**Committee of Experts on the Transport of Dangerous Goods
and on the Globally Harmonized System of Classification
and Labelling of Chemicals****Sub-Committee of Experts on the Transport
of Dangerous Goods
Forty-ninth session**

**Issues relating to the Globally Harmonized System of
Classification and Labelling of Chemicals:
Classification criteria for flammable gases****Sub-Committee of Experts on the Globally Harmonized
System of Classification and Labelling of Chemicals
Thirty-first session**

**Joint work with the Sub-Committee of Experts on the
Transport of Dangerous Goods (TDG Sub-Committee)****Comprehensive consideration of the hazard class
flammable gases in the course of introducing new
classification criteria****Transmitted by the experts from Germany, the European
Industrial Gases Association (EIGA) and the European
Chemical Industry Council (CEFIC)¹**

Decision logic 2.2 (option 1)

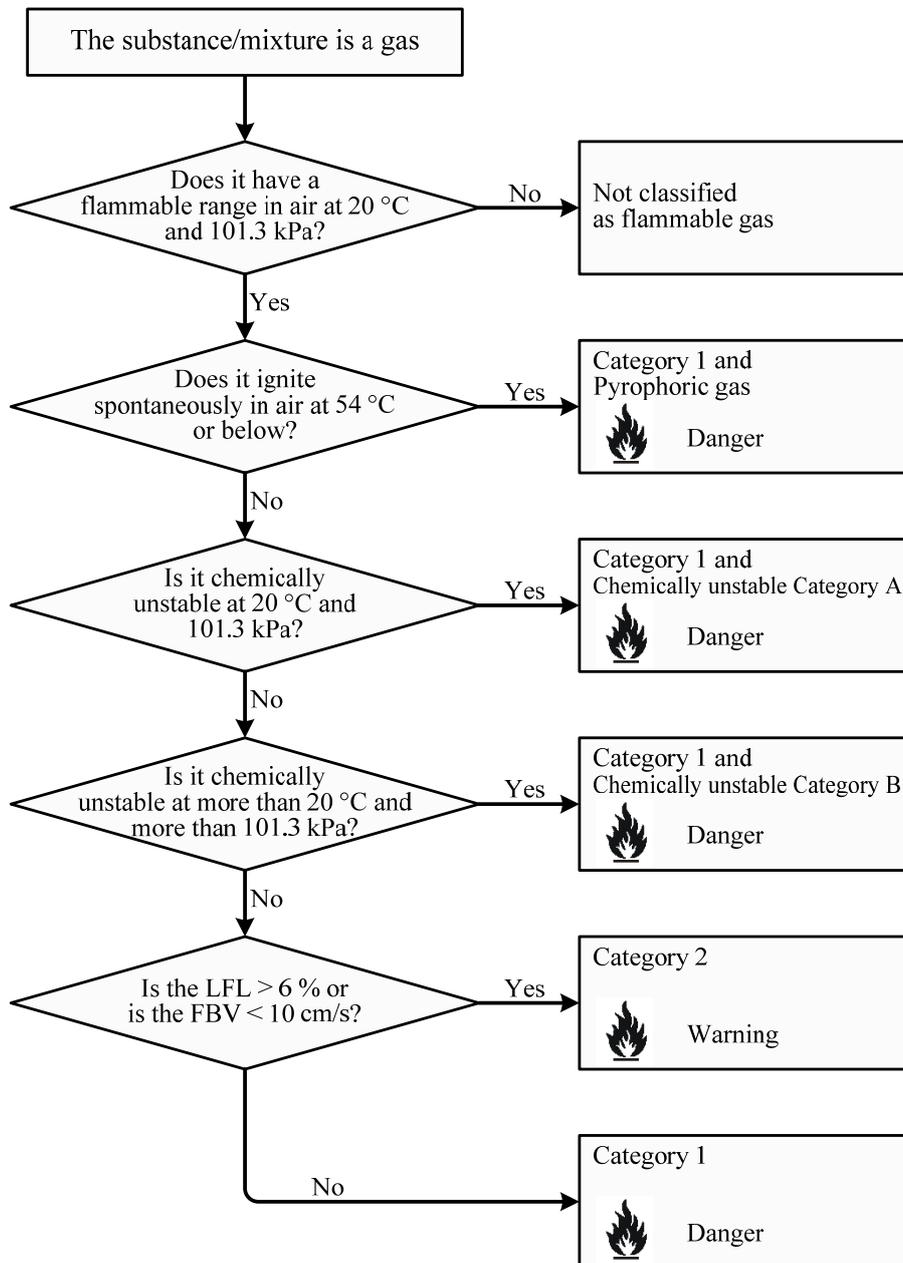
The sub-committees are invited to consider the proposed amendments to Chapter 2.2 as shown below. The proposal contains two alternative decision logics, one with reference to transport of dangerous goods and one without. The sub-committees are invited to choose the option deemed most appropriate.

To classify a flammable gas, data on its flammability, on its ability to ignite in air and on its chemical instability are required. The classification is according to decision logic 2.2-(a).

~~**Decision logic 2.2 (a)**~~

(current decision logic 2.2 (a) is deleted.

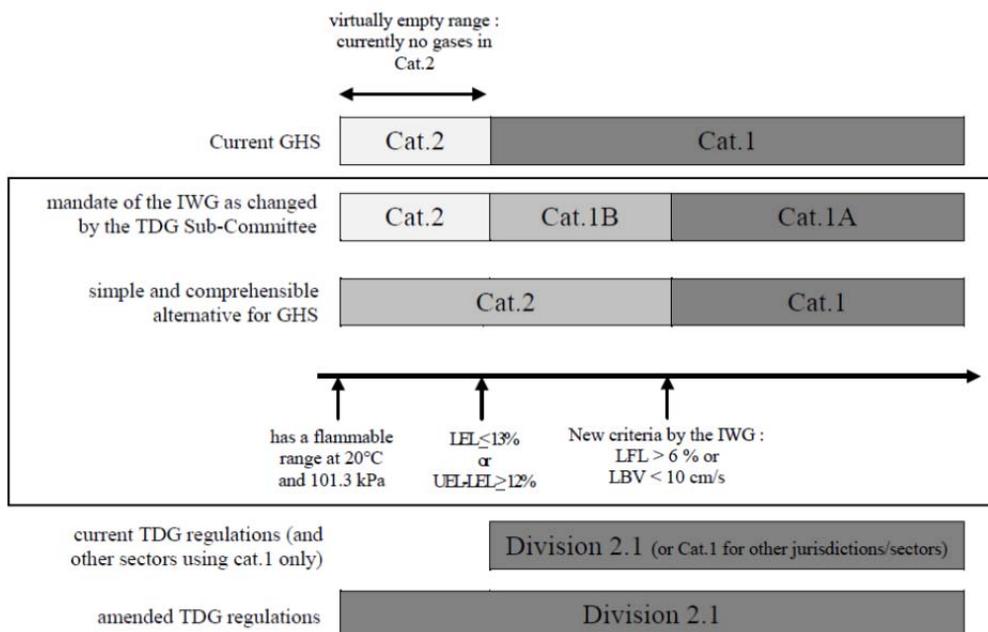
5. The proposed simplification, the sensible use of category 2 by the proposal and the possibility to achieve harmonization also with TDG are shown in the following figure:

6. Furthermore, the above proposal would not only keep the categorization of flammable gases as simple as possible, it can also be used to merge the three flow-charts, thus clearly communicating the interfaces between the categories of flammable gases and the supplemental categories for pyrophoric and chemically unstable gases.
